**TO:** Vienna Construction Industry  
**FROM:** Michael Gallagher, Department of Public Works Director  
**DATE:** September 26, 2018 (Revised October 26, 2018)  
**SUBJECT:** Lot Grading Definition ( 18-002 LTI )

Beginning October 1, 2018, The Town will have a revised Lot Grading Definition that will read as follows:

Figure 1 - Building Height Calculation and Lot Deviation Table

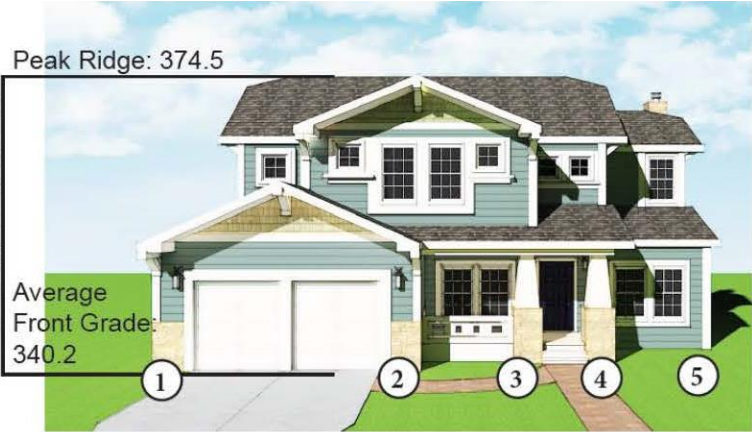
The Town will also be requiring spot elevations, see diagram on next page, along the perimeter of the home on the final plat to verify the lot meets the definition. **Note: The spot elevations around the footprint of the house can be included with the building height certification survey.**
